FIELD OBSERVATION – FOURTH FLOOR IN-WALL AND CEILING ELECTRICAL REPORT 08-02-2016

AEI Project Number and Name: 14018 – The Park Danforth

Unit 1404

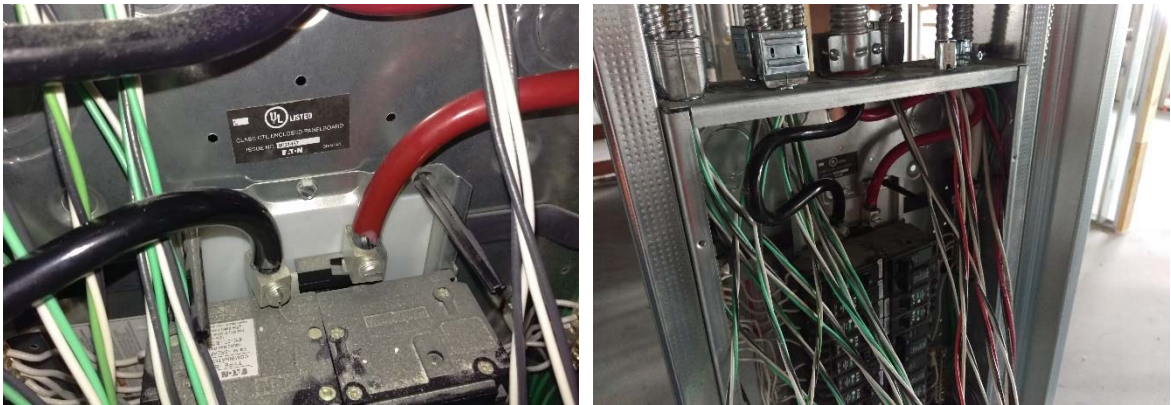
1. A main-lug termination in the load center has bent the load center main bus. Replace load center interior.
